RE: John Edwards Drain, Maple Knoll Section 5 Arm

John Edwards Drain, Maple Knoll Section 5 Arm

Re: John Edwards Drain: Maple Knoll Section 5

# MAPLE KNOLL SECTION FIVE

SHEET NO. C200  
JOB NO. 3467655

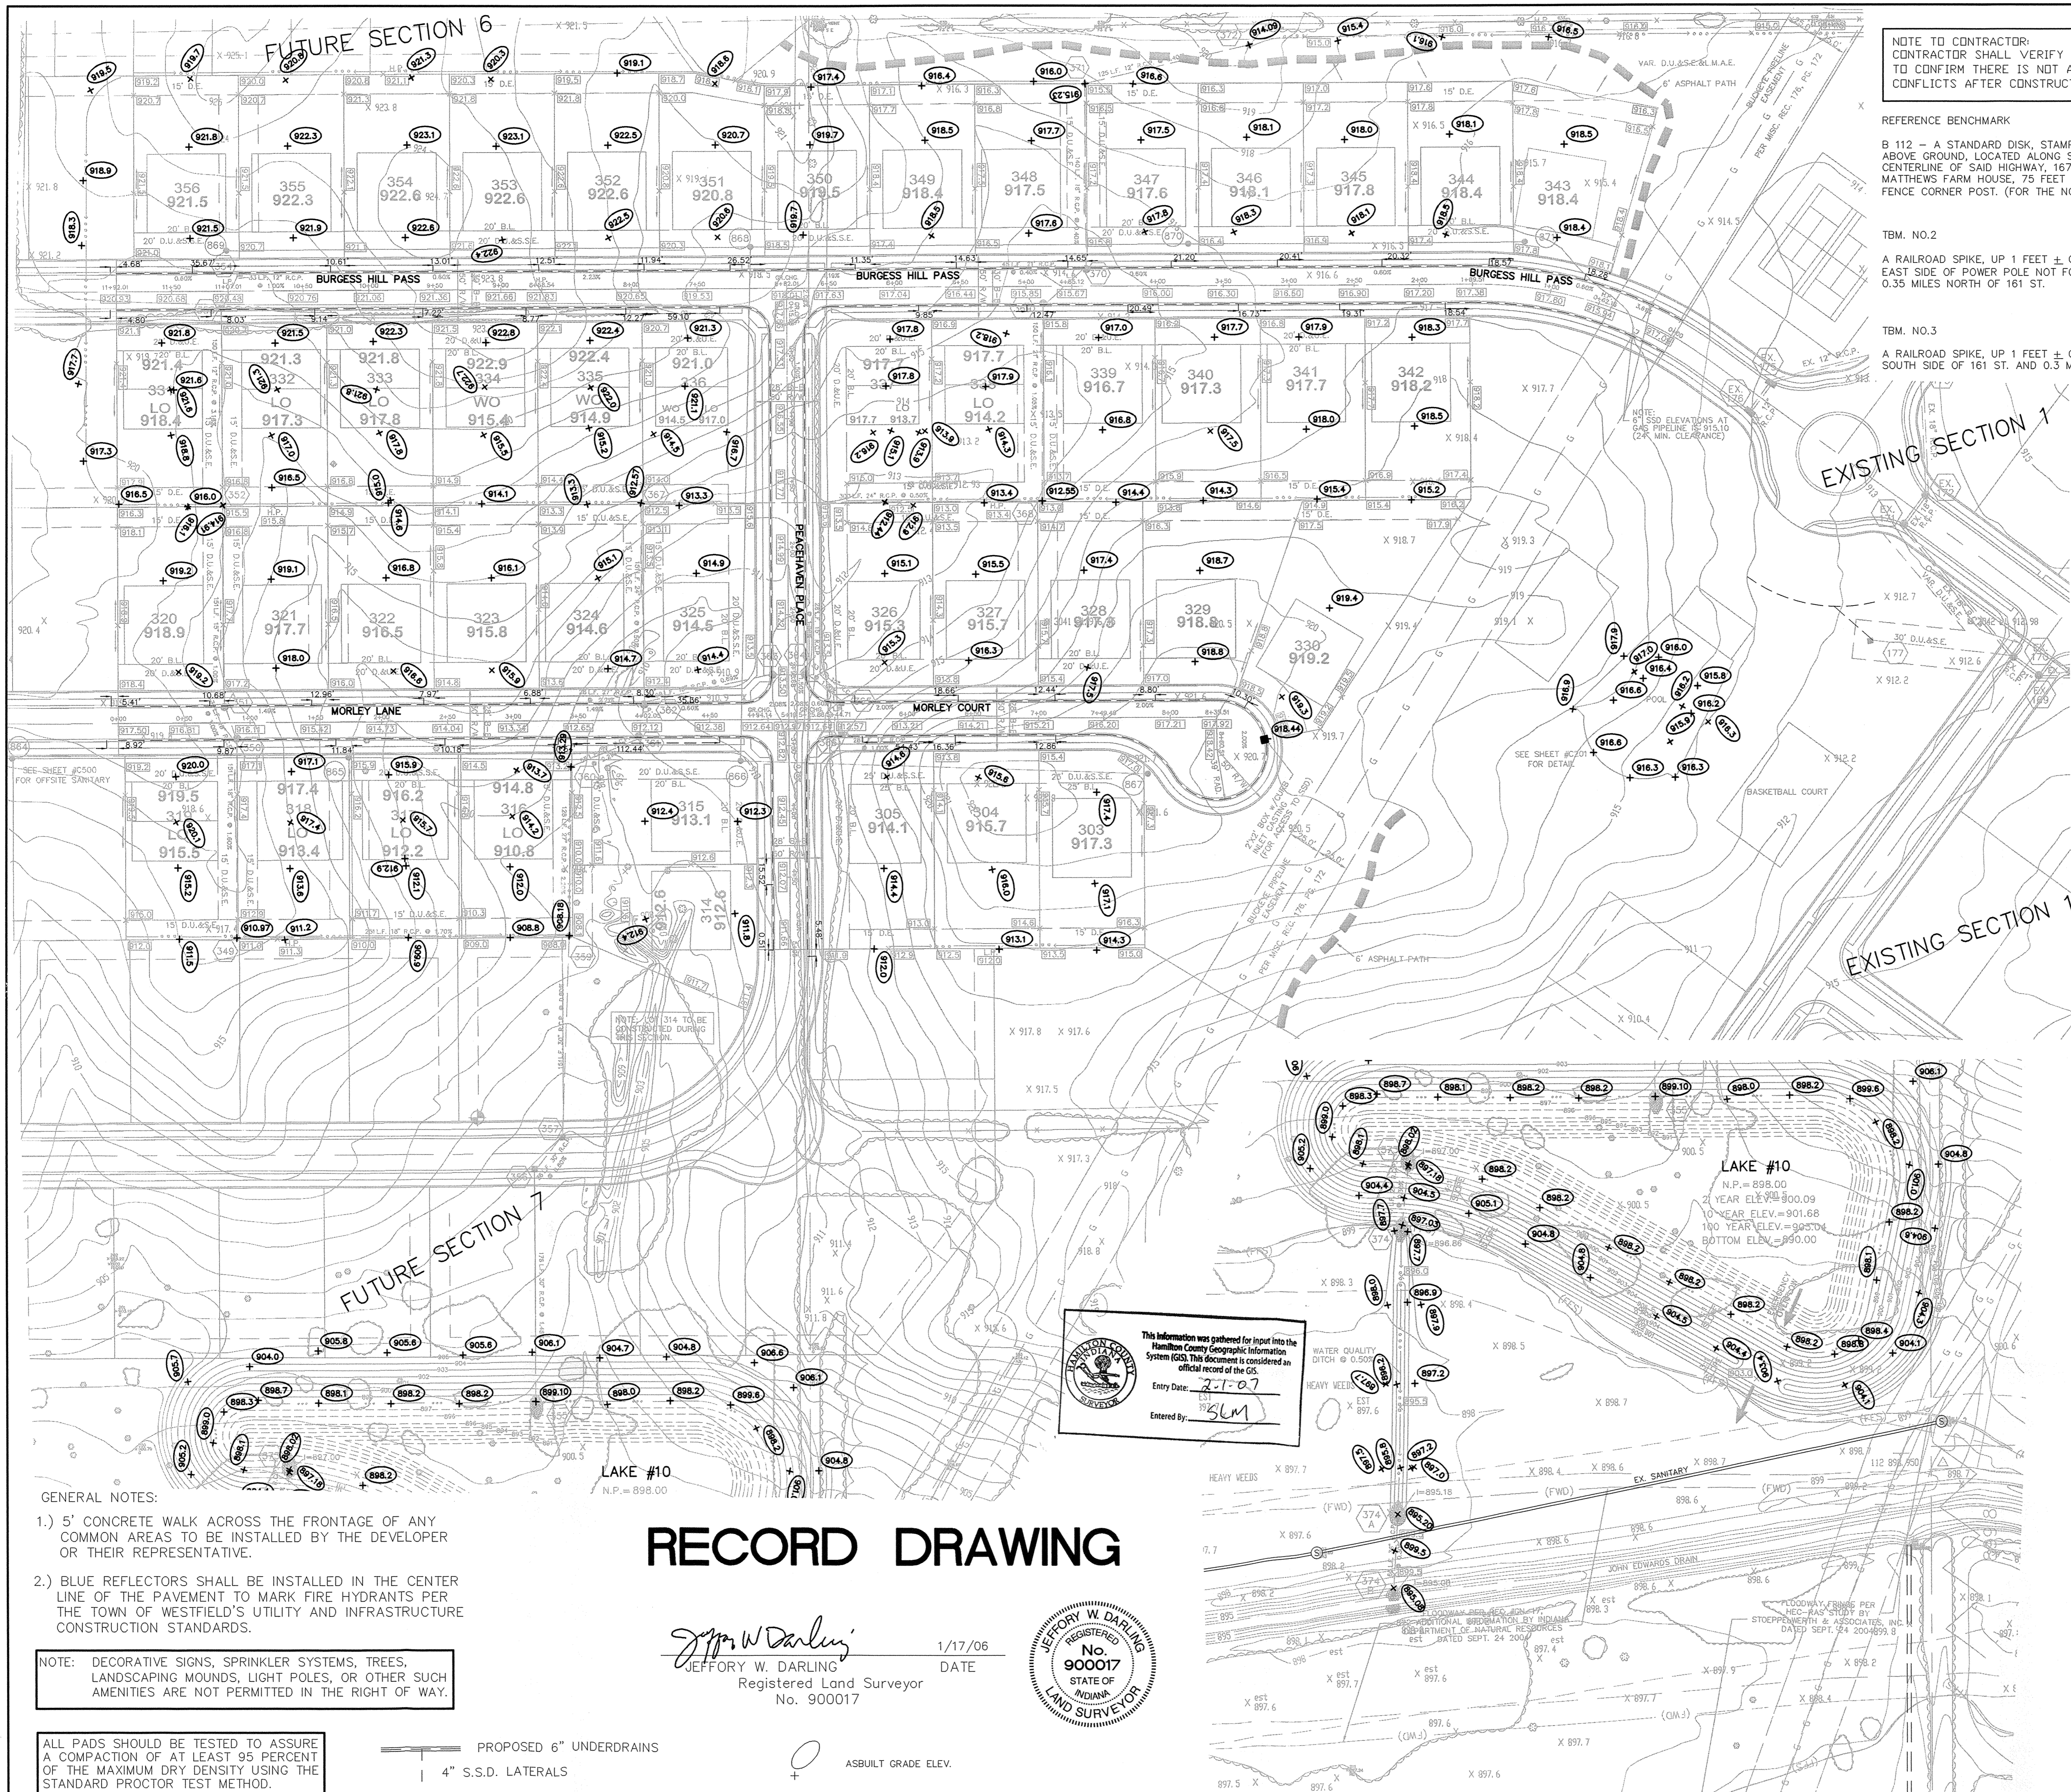
The open ditch listed above is that within future Section 7 between Lake #10 and the Edwards open ditch. This would be between structures 374 and 374A as shown of sheet C200 of the plans for Section 5.
